PRODUCT CHANGE NOTICE

IRHLNA797064 [2N7622U2]

60V, P-Channel, TID Hardened MOSFET in a SMD-2 Surface Mount package

UPDATE MAXIMUM SAFE OPERATING AREA

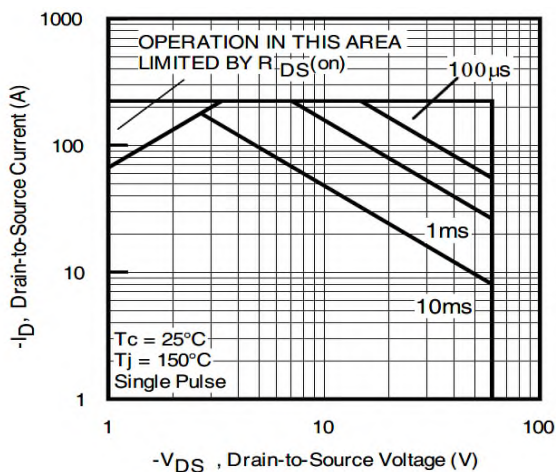
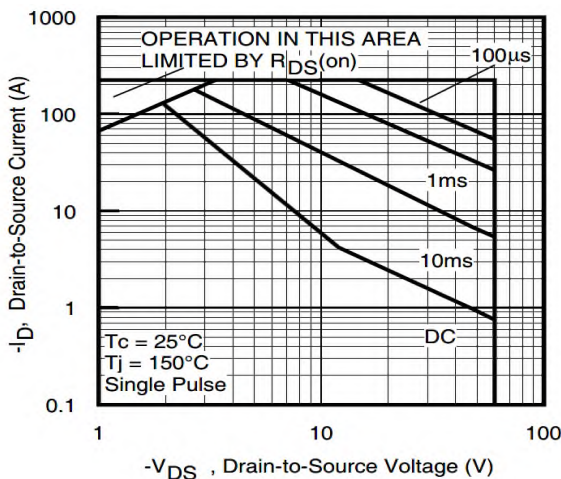
From:

To:
